**OAK BROOK PARK DISTRICT –
1315 & 1425 KENSINGTON ROAD
Variations – Allow 80’ light poles on new Ball Fields**

STAFF REPORT

CASE NOS: 2020-03-ZO-VAR

DESCRIPTION: Variation to allow six 80-foot high light standards to illuminate two sports fields.

PROJECT NO.	19-0117
DATE	02/25/2020
SHEET	1 OF 2
LIGHT LM

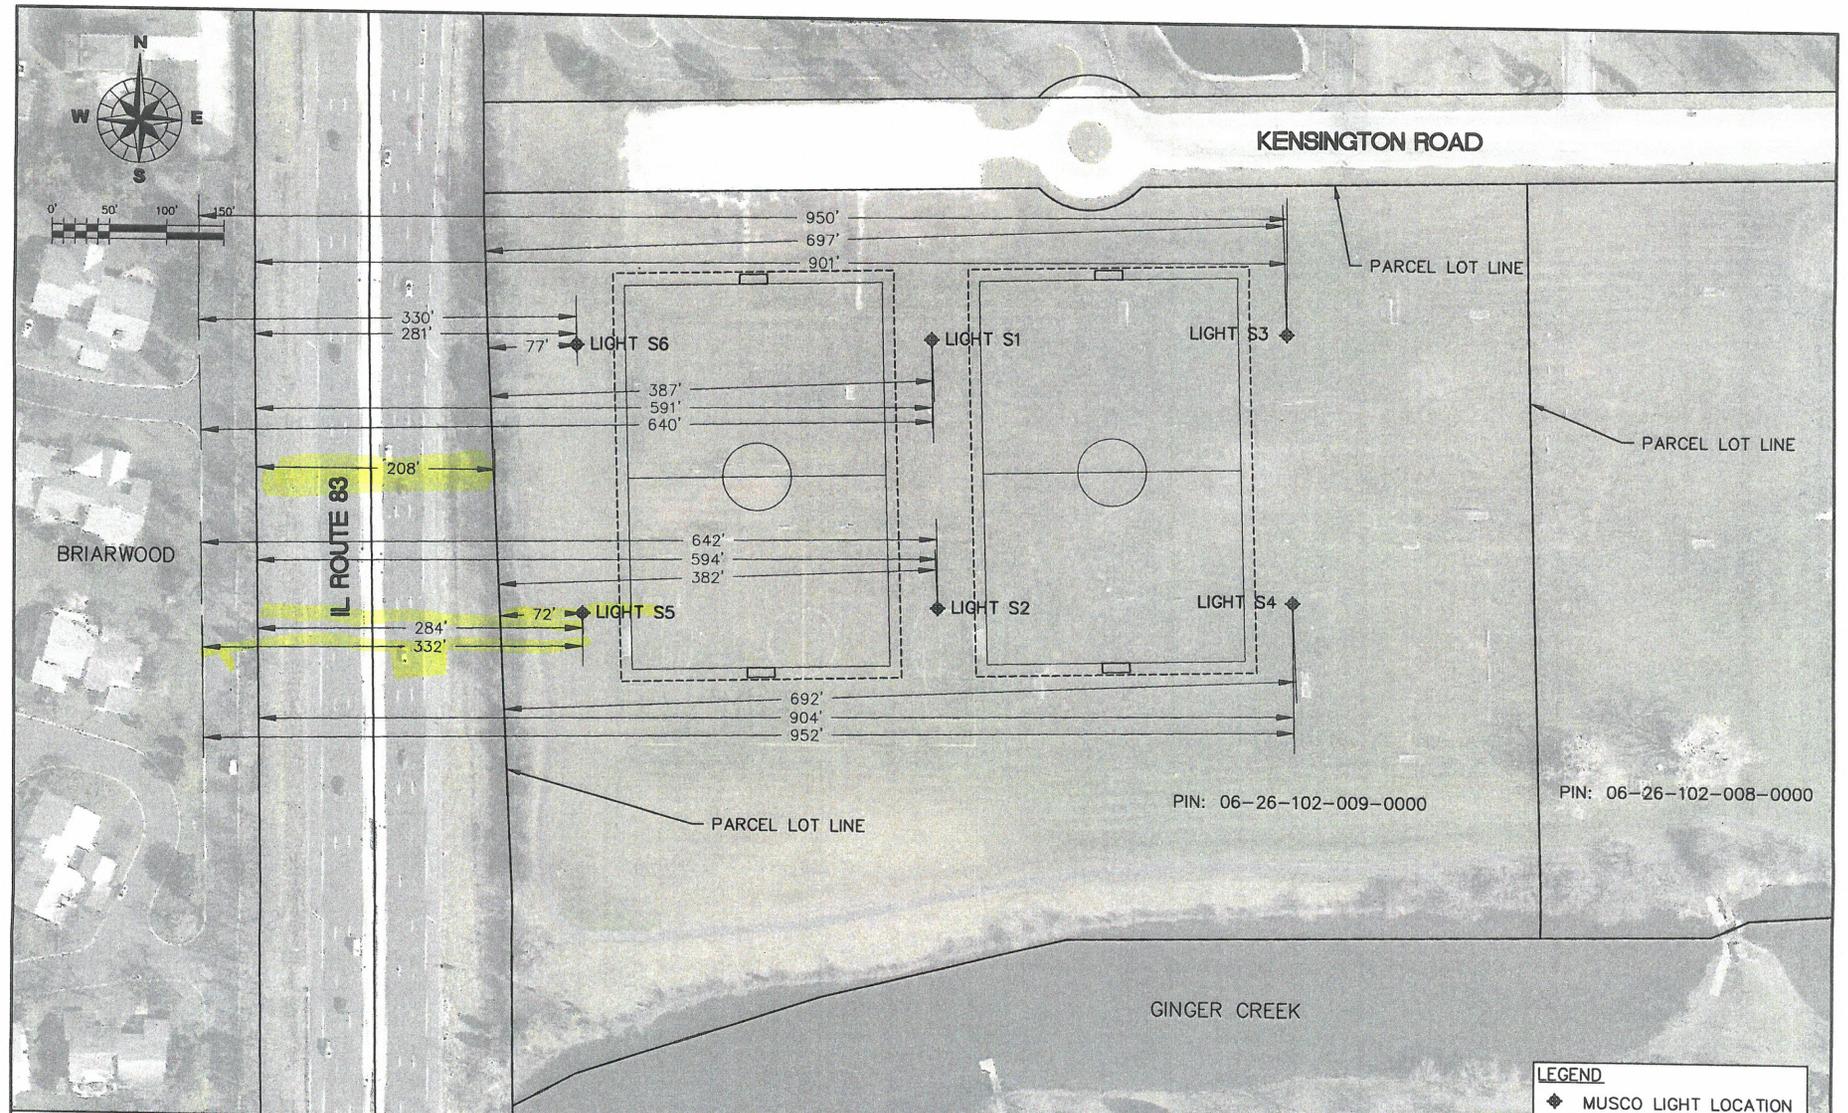
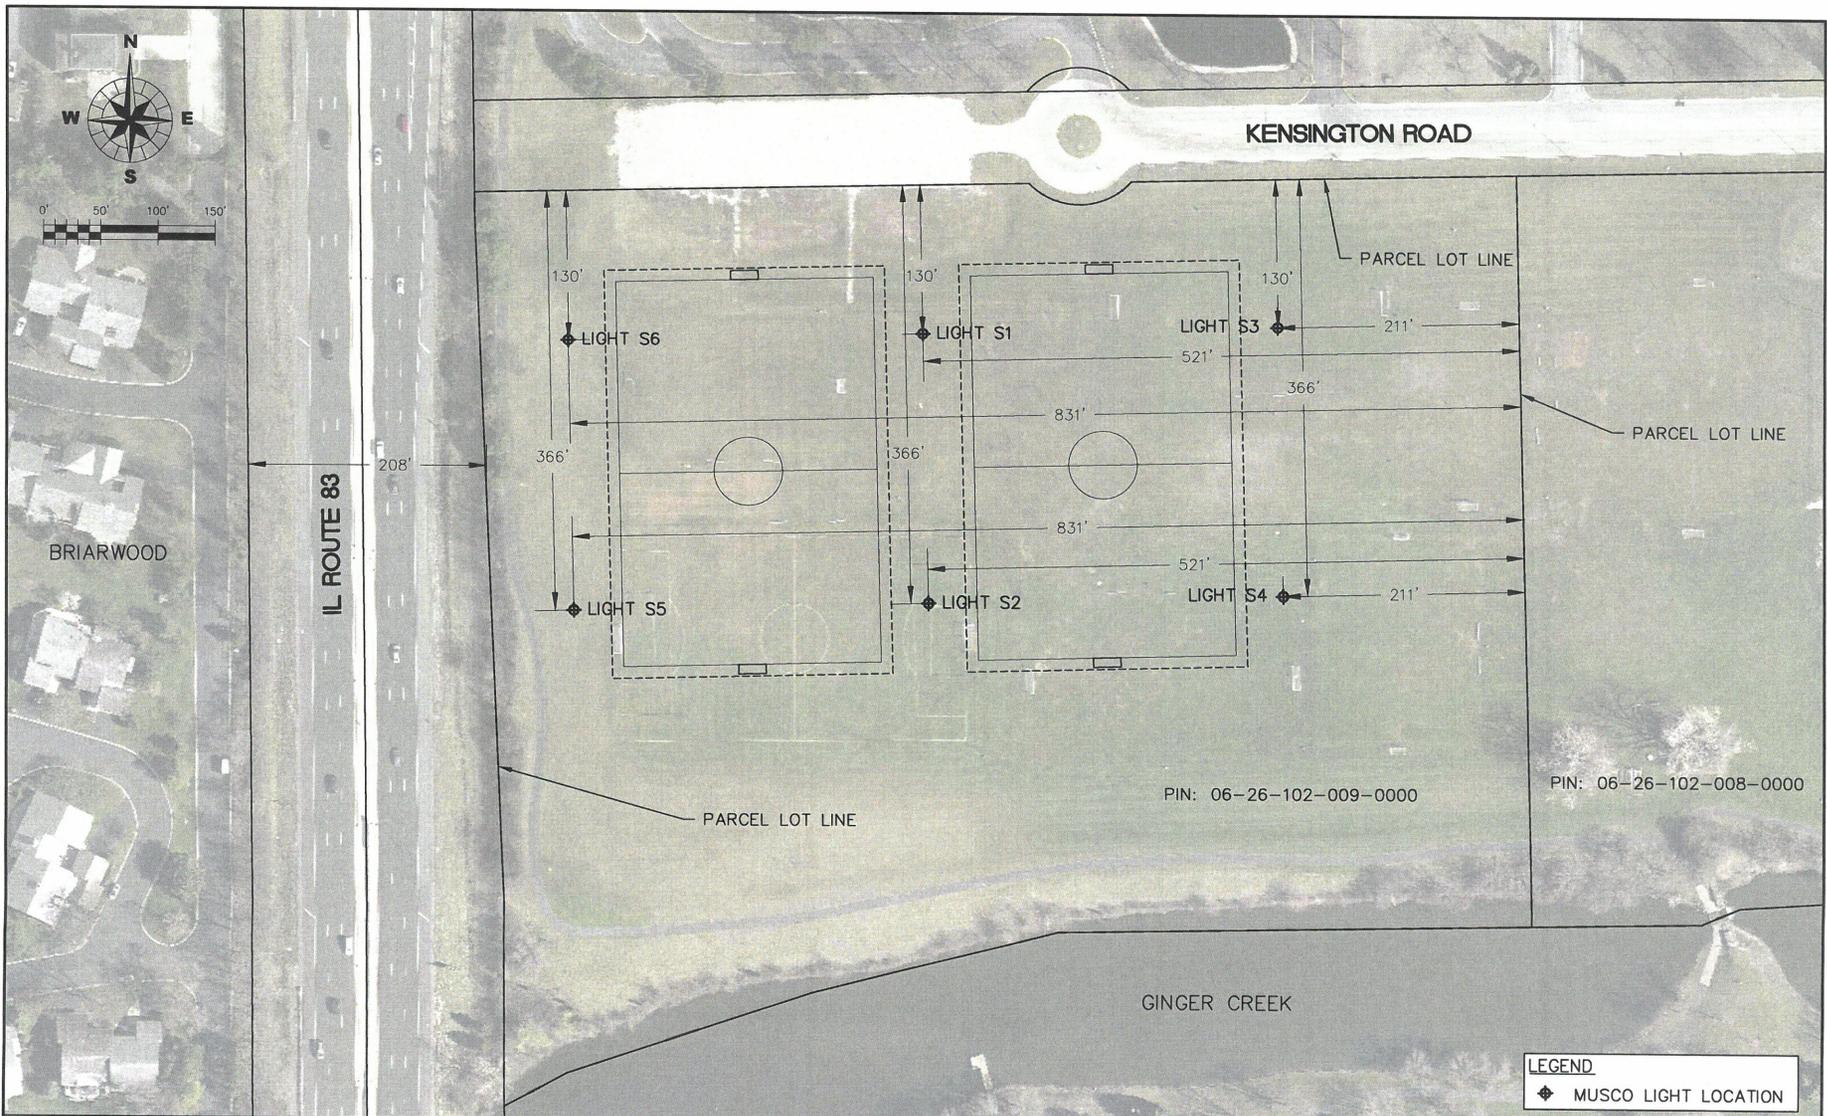
1. The Highway Property Line Illumination Exhibit indicates a maximum illumination of 0.00-footcandles along the west edge of pavement of the southbound lanes on Illinois Route 83. Table 302.15, found in Title 10-1-2 of the Village Code, allows a maximum illumination of 0.30-footcandles in residential zoned areas at any point along the property line of the impacted property.
2. The Blanket Grid Illumination Exhibit indicates an illumination of 0-footcandles along the approximate centerline of the Kensington Road right-of-way. Table 302.15 allows a maximum illumination of 0.8-footcandles at any point along the property lines for properties on the north side of Kensington Road.

The lighting documents have been reviewed and found to comply with the Village's lighting regulations. If you have any questions, please contact me at 630-368-5144 or jpatterson@oak-brook.org.
